Appl. No. 10/016,132  
Response dated February 17, 2005  
Reply to Office Action mailed November 17, 2004

Amendments to the Drawings:

#### REMARKS

**FIG. 1a**

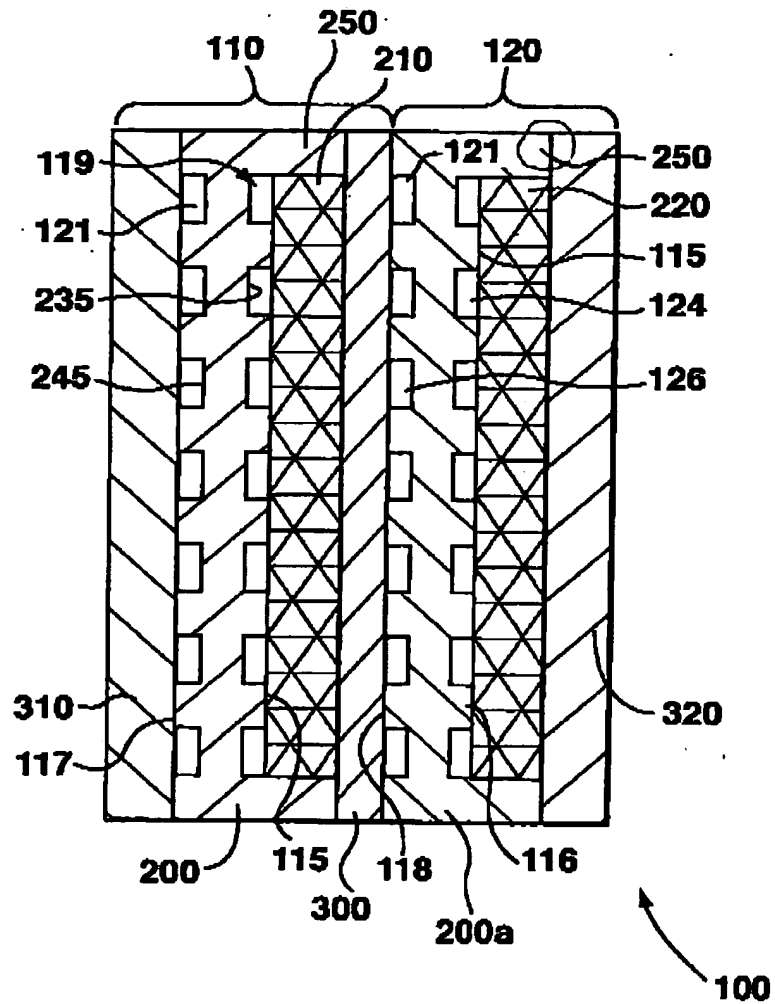
The attached sheet of drawings contains changes to Figure 1a. This sheet, which contains a replacement sheet, contains Figure 1a, replaces the original sheet containing Figure 1a.

As requested by the Examiner, an amended Figure 1a is attached, showing a proposed correction to the lead line for one of the reference numerals 250, to ensure that this reference is used consistently.
